### **REMARKS**

Claims 1, 5 and 18 are amended herein. Upon entry of this amendment, claims 1-18 and 27-34 will be pending in the above-identified application.

# FIGURE

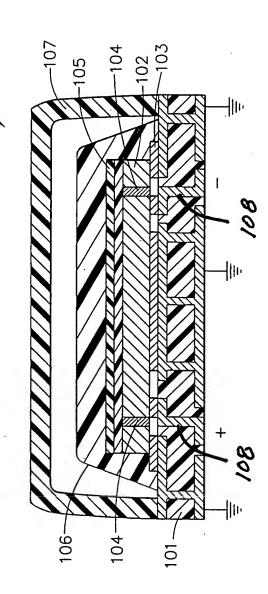
Applicant respectfully requests reconsideration of the rejection of the drawing under 37 C.F.R. § 1.83(a). A proposed drawing amendment is enclosed. The amendment adds the numerical designation 108 to the drawing. The corresponding portion of the specification is likewise amended to make clear the location of the terminals. Accordingly, the Rule 83 objection has been overcome and applicant requests it be withdrawn.

Enclosed is a copy of the drawing figure showing proposed changes in red. Also enclosed is a Replacement Sheet of the formal drawing incorporating the proposed changes.
